Hilton A14 - Further Statement

A14 Cambridge to Huntingdon improvement scheme

Statement of Common Ground between Highways England and Hilton Parish Council

Reference: HE/A14/EX/98/PC11

6 Appendix B – Bridge height requirements

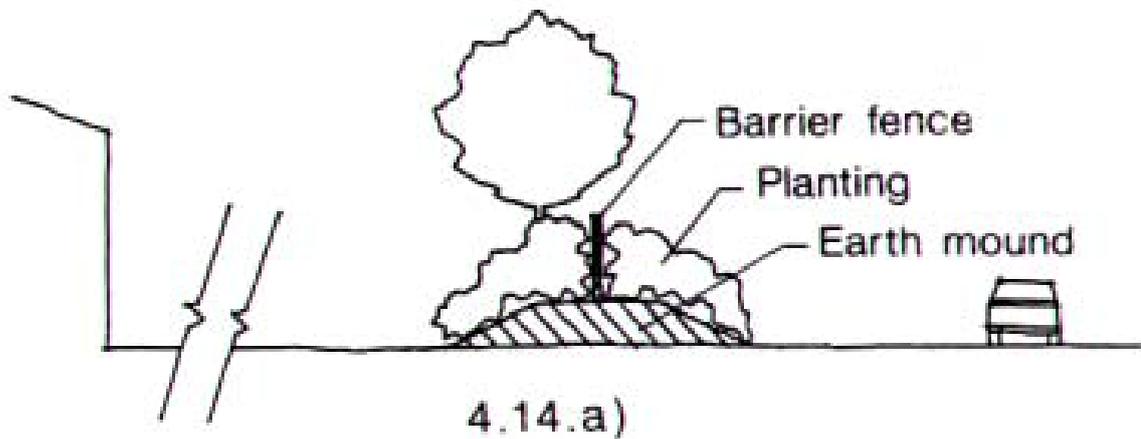
4	Design and Engineering Standards Height of overbridges	Clarification is required on actual height of bridges above existing ground level. The Potton Road and Hilton Road bridges appear to be up to 2	There is scope for refinement at detailed design stage when exact structural options are determined. There will be opportunity for consultation	Under discussion.

<p>metres higher than what is actually required with Potton Road at 11m; and Hilton Road bridge at 10.7m. More detailed engineering drawings are required and engagement at the detailed design stage.</p> <p>Highways England subsequently stated the additional height is due to the single span of the bridge across all six lanes with no central support.</p>	<p>and engagement during detailed design stage, at which stage there will be opportunities to comment on designs.</p> <p>At detailed design the elevation of side roads crossings will be minimised to reduce both impacts and costs. Please refer to Appendix B.</p> <p>In the meantime we will continue to discuss the height and appearance of structures with you.</p>	
5	Landscape and visual effects	<p>Concerns regarding the visual impact and appearance of structures along the route.</p> <p>Hilton Parish Council request to get the best mitigation possible for the people of Hilton.</p> <p>Hilton Parish Council also questions the rules and guidelines which Highways England contractors will have to work to.</p> <p>Hilton Parish Council are concerned about the impact of light pollution from high sided vehicles hence the wish for a higher barrier up to 4m in height.</p>	<p>In view of the concerns raised about visual impacts as the road passes Hilton (in particular relating to the Potton Road over bridge), a desk study has been undertaken to identify a proposed additional and representative viewpoint on the north edge of the village which places the overbridge clearly in view without intervening screening. It is to show the proposed scheme and the Potton Road bridge before construction and at year 1 and year 15 after construction.</p> <p>This viewpoint was shared with Hilton Parish Council and a site meeting was held with the Parish Council on 3 June 2015 to assess the suitability of this and potential alternative viewpoints suggested by the Parish Council. The Parish Council concurred that Highways England's proposed viewpoint is suitable for an additional photomontage.</p> <p>The photomontages from the agreed viewpoint can be found within Highways England's Response to the First Written Questions</p>	Under discussion.

As set out in Highways England’s response to the First Written Questions, Question 1.9.9, the majority of the new bridge structures on the scheme, including those on the Huntingdon Southern bypass section, are similar in nature and have been developed as a family of structures known as the ‘Standard Overbridges’.

Preliminary design of this family of structures has been carried out with key consideration to the impact on the landscape, which is predominantly flat and open rural in nature. Solutions with ‘open abutments’, with small bankseat abutments, allowing the slopes of the approach earthworks to extend below the bridge deck, have been preferred as they are less visually obtrusive. A three span arrangement has been chosen as this is more visually appealing and avoids maintenance issues with a two span arrangement with pier in the A14 central reserve.

At detailed design the elevation of side roads crossings will be minimised to reduce both impacts and costs.

The typical height of an overbridge is 11.2 metres above ground level, this height is a summation of the following requirements:

1. The height of the mainline above ground level is driven by drainage requirements;
2. A 5.3 - 5.7 metre headroom is required under the bridge to accord with design standards (this depends on the structures impact resistance, so the scheme uses 5.7 metre structure to keep structure options open);
3. A structural depth of 2.0 metres is typically required (dependent upon the structure type and span);
4. Allowance for construction on bridge;
5. Allowances for road crossfall, gradient, construction and settlement etc.

- $3\text{m} + 5.7\text{m} + 2\text{m} + 0.5\text{m} = 11.2$ metres above ground level.
